2nd Further Information

**Proposed Temporary Container Vehicle Park for a Period of 3 Years
in “Residential (Group E)” Zone, Lots 2356 S.A, 2356 RP, 2357 (Part), 2358 (Part), 2360 S.C,
2360 RP, 2361, 2362, 2364 (Part) and 2365 (Part) in D.D. 129 and Adjoining Government Land,
Lau Fau Shan, Yuen Long, New Territories**

(S.16 Planning Application No. A/YL-LFS/616)

Response-to-Comment (RtC)

Annex 1
Landscape Plan

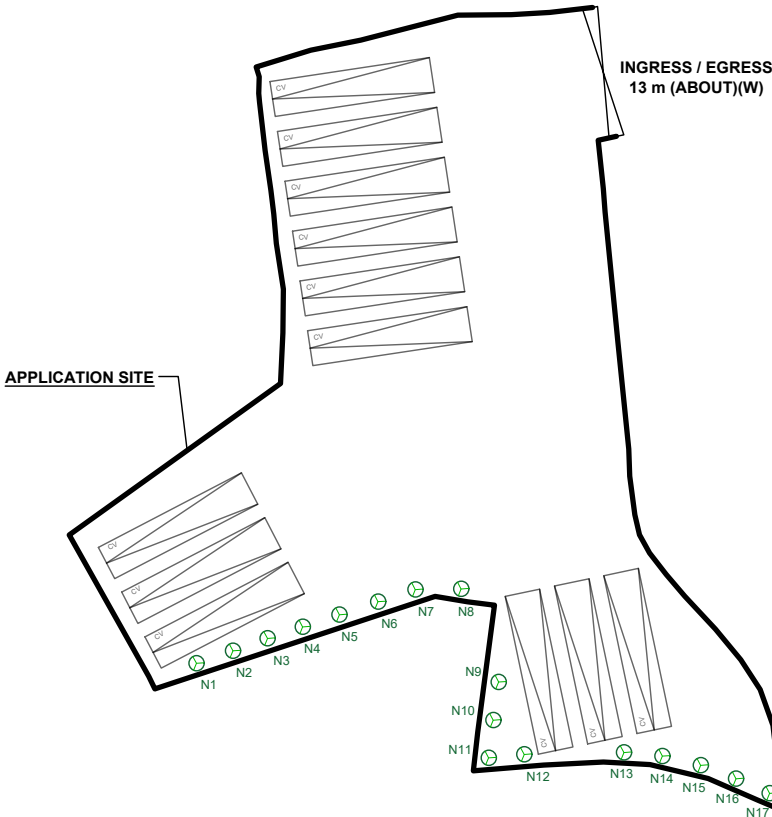
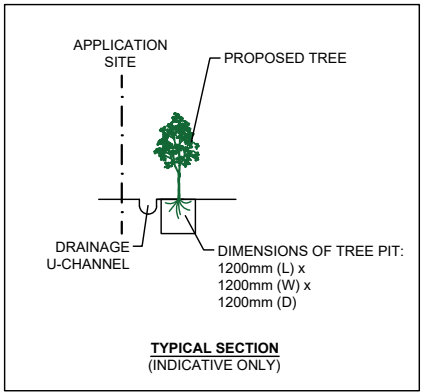
- (i) The applicant provides the following information in response to the comments from the District Planning Officer/Tuen Mun and Yuen Long West, Planning Department (DPO/TMYLW, PlanD):
- the applicant proposes to plant 17 nos. of new trees along the southern periphery with a view to serving as a landscape barrier between the proposed development and the village houses to the south. The landscape plan is enclosed at **Annex 1**; and
 - 2.5 m high solid metal fencing will be erected along the site boundary to minimise the potential noise, landscape and environmental nuisance to the surrounding area. The boundary fencing will be installed properly by a licensed contractor to prevent misalignment to ensure that there is no gap or slit on boundary wall.

APPLICATION SITE AREA	: 2,811 m ²	(ABOUT)
NOS. OF TREE TO BE PLANTED	: 17	(N1 TO N17)
SPECIES OF NEW TREES	: <i>BAUHINIA</i> x <i>BLAKEANA</i>	
HEIGHT OF NEW TREES	: NOT LESS THAN 2.75 m	
SPACING OF NEW TREES	: NOT LESS THAN 4 m	
DIMENSION OF TREE PITS	: 1.2 m (W) X 1.2 m (L) X 1.2 m (D)
